**NORTH BEND PARKS COMMISSION MEETING**  
**September 27, 2023, 6:30pm**  
**North Bend City Hall**  
**920 SE Cedar Falls Way, North Bend, WA**

TO: North Bend Parks Commission

FROM: Mike McCarty, Senior Planner

SUBJECT: Review of proposed Ichijo NB-40 Subdivision on-site park improvements

**PRELIMINARY LANDSCAPE PLAN  
NB40**

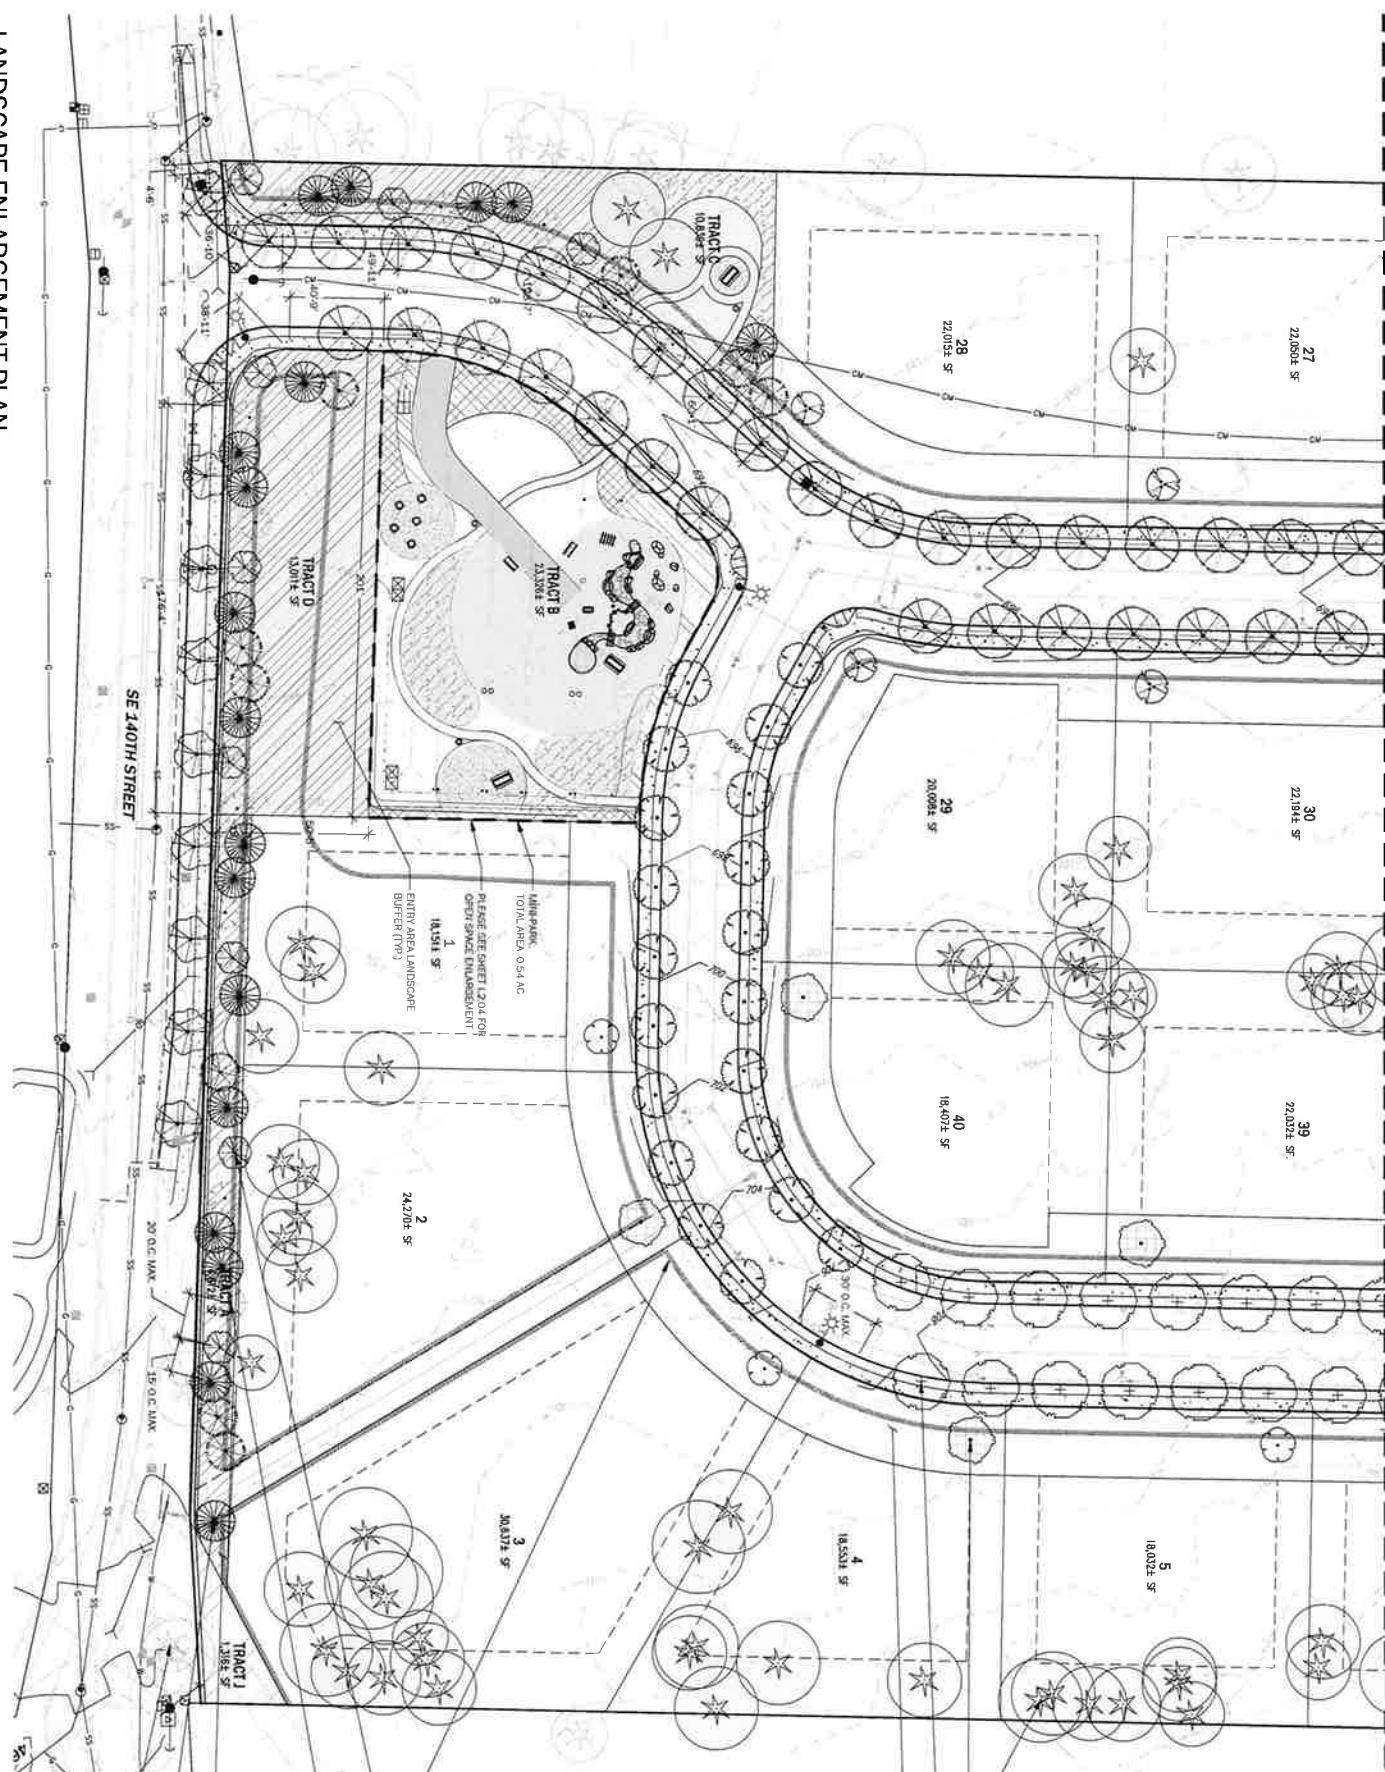
10) NBMC 14.20.320(D) provides that public access shall be located and designed to respect private property rights. The beginning of trail to the river overlook, as proposed on the site plan (see Sheets P3-03 and P3-04), travels immediately beside the rear of lots 22 and 23 within the adjacent Tannerwood Subdivision (3782 and 3794 SE 16<sup>th</sup> Street respectively). See photo 1 above showing this area. To provide additional privacy for these two existing homes from people using the trail, the trail should be relocated further north, and some native evergreens planted between the trail and the rear of these lots. A recommendation has been provided below addressing this.

1. Backyard privacy: To respect privacy of adjacent existing residences consistent with NBMC 14.20.320(D), within Tracts F and I, shift the trail and public trail easement further to the north away from the immediate backyard boundaries of 3782 and 3794 SE 16<sup>th</sup> Street within the adjacent Tannerwood Subdivision, and plant a 10-foot buffer of additional native evergreens in the existing open area behind these lots to provide additional screening and privacy. There is an alternative existing trail just to the north of the proposed trail at this location that could be improved for the future trail corridor to get down the trail/old roadbed switchback at the slope.

7. Additional tree retention in Tracts C and D Entry Areas: As required per NBMC 18.18100(A)(1)(g), all viable existing trees shall be retained within the entry area tracts. Revise the clearing limits and landscape plan to retain additional trees that do not have root protection zones extending into constructed features. (The clearing limits can be adjusted more carefully with tree protection fencing provided accordingly).
8. Tract D more trees: Tract D contains insufficient trees per the Type 2 landscape standards in NBMC 18.18.080(B). Plant additional trees consistent with this standard.
9. Provide a more natural, curvilinear pattern to the grass/shrubs transition between Tract B and Tract D, not a straight line. Grass may extend into the northern portion of Tract D for such purpose.

## LANDSCAPE ENLARGEMENT PLAN

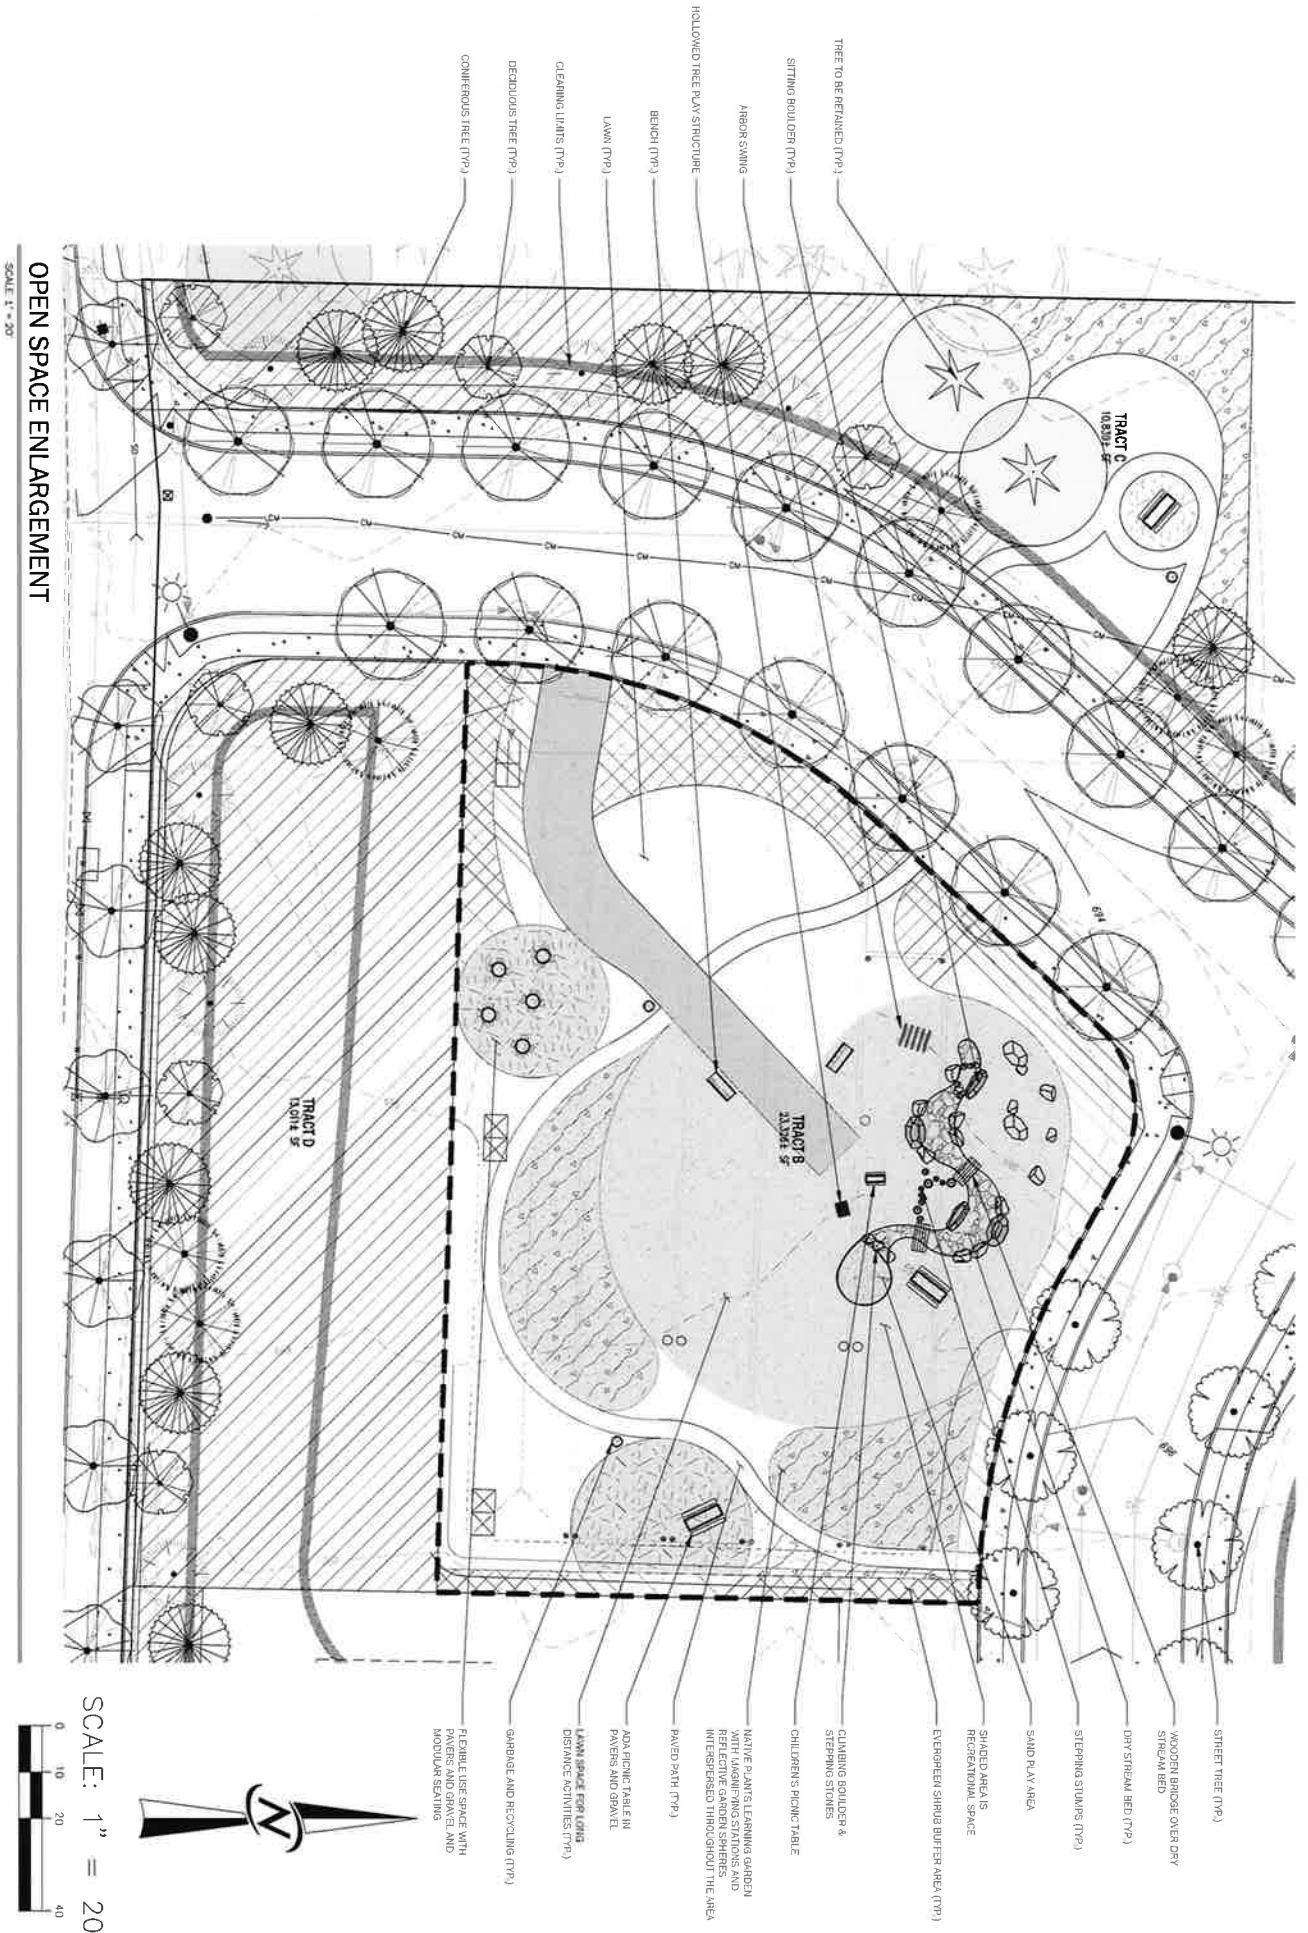
- 4) NBMC 17.25.030(B)(4) requires that recreation space not include at-grade stormwater features except as necessary to account for stormwater generated within the recreation space itself. While Tracts B and E contain stormwater vaults, these vaults are underground, preserving at-grade space for

recreational amenities and landscaping. However, Tract B contains an access roadway for service of the stormwater vault that extends into a significant amount of the park area and does not correlate with the design of the park features, seemingly out of place within the park. A recommendation is provided below to redesign the driveway and park features to better work together.

- 6) NBMC 17.25.060 provides requirements for minimum park features, play equipment and infrastructure. It requires that mini parks contain active and passive recreational facilities such as children's play equipment, picnic areas and/or tables, benches, and or pea patch garden plots, and be located adjacent to and highly visible from a public right-of-way. Of note, "Children's Play Equipment" as defined under 17.25.020 may also include natural elements such as rocks, logs, or stumps safely installed, anchored and arranged in such a manner as to create a play space for enjoyment by children.  
The applicant has shown conceptual mini park improvements within Tract B meeting these criteria. Conceptual mini park improvements include paved pathways, climbing boulders, an arbor swing, a native plants learning garden with magnifying stations and reflective garden spheres, a sand play area, a wooden bridge over a simulated dry stream bed landscape feature, a hollowed-tree play structure, picnic tables and benches, garbage and recycling bins, and open lawn space. See the detailed plan for this tract on Sheet L2.04, and specs on L2.32.

4. Mini-Park features: Per sheet L2.31, specs and amenities for the mini park are noted as “conceptual and subject to change in the final design”. Final design shall be reviewed for approval together with the final landscape plans against the criteria for mini parks in NBMC 17.25, and shall not contain substantially less than that provided with the concepts shown herein.

5. Incorporate Tract B access road: Redesign the vault access road as a feature within the Tract B mini-park rather than in a manner that ignores/ is in contrast to the other park features. Currently it doesn’t relate to the other trail, play, or landscape features within the mini park, and seems intrusive rather than a part of the park design.

6. Tract B additional entry pathway: Provide a pathway entry to the mini-park from the intersection pedestrian apron. This will be a natural point of entry, and the native vegetation there will become trampled without a pathway focusing walkers.
